July 31, 2012

DOMINION NUCLEAR CONNECTICUT, INC.
MILLSTONE POWER STATION UNIT 2
PROPOSED TECHNICAL SPECIFICATIONS TO ADOPT TSTF-510, "REVISION TO STEAM GENERATOR PROGRAM INSPECTION FREQUENCIES AND TUBE SAMPLE SELECTION," USING THE CONSOLIDATED LINE ITEM IMPROVEMENT PROCESS

Marked-up Technical Specifications Changes

3.4.5 Steam Generator (SG) tube integrity shall be maintained.

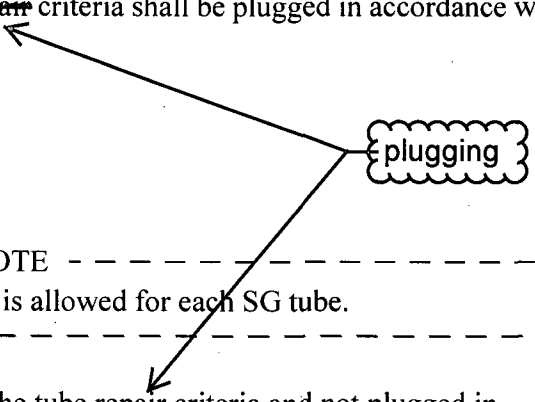
All SG tubes satisfying the tube ~~repair~~ criteria shall be plugged in accordance with the Steam Generator Program.
